5 September 2023

Resource Consent Application RM23–0010 for comprehensive stormwater consent for existing stormwater discharges from the Whakatane Township and associated network structures located in the bed/bank of a river or stream, and/or the CMA – Request for Further Information pursuant to Section 92 of the Resource Management Act 1991 (RMA)

SUBJECT **Whakatāne Comprehensive Stormwater consent application: Response to Section 92 request for further information**

Figure 1: Whakatane landslide risk (source: Landslide Risk Assessment Map)

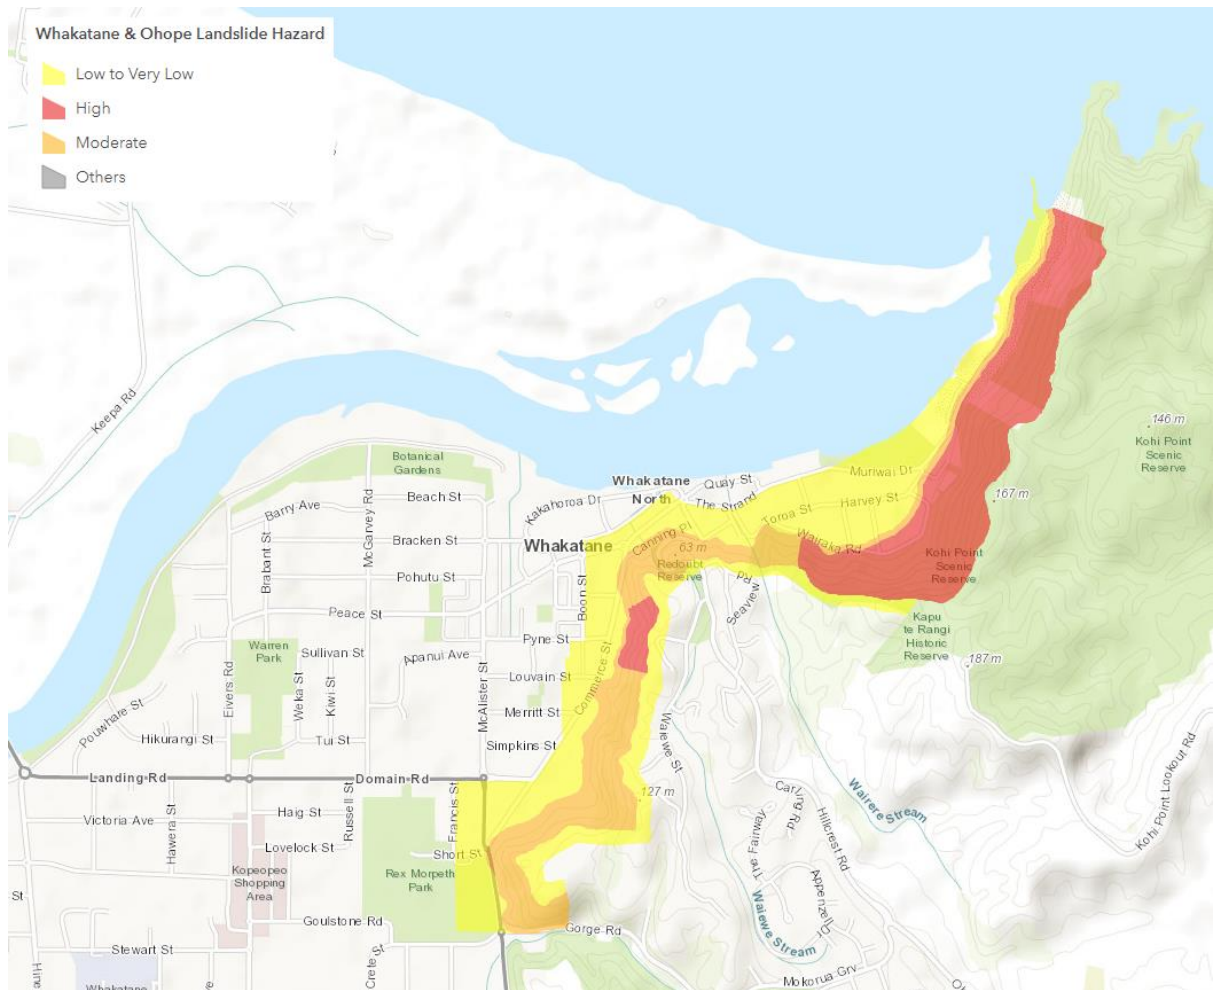
c) *Section 7.6 of the application discusses Natural Hazards and identifies there are areas of risk within the stormwater network. It is noted that the management of the stormwater network in regard to natural hazards (with the exception of climate change) is not addressed in the Stormwater Catchment Management Plan (CMP). Please address these matters in the CMP, or if not, please provide an explanation of why these matters are not addressed in the CMP.*

As noted in the resource consent application (page 119), the potential impact of natural hazards is considered when infrastructure is designed and installed. Future land use changes or developments need to account for these hazards via any consent or plan process.

There is a high risk of landslides on the Whakatāne escarpment, as indicated on figure 1. It is not considered necessary to specifically address this risk in the CMP due to the small area of the stormwater network that could potentially be affected and the limited impact of any event.
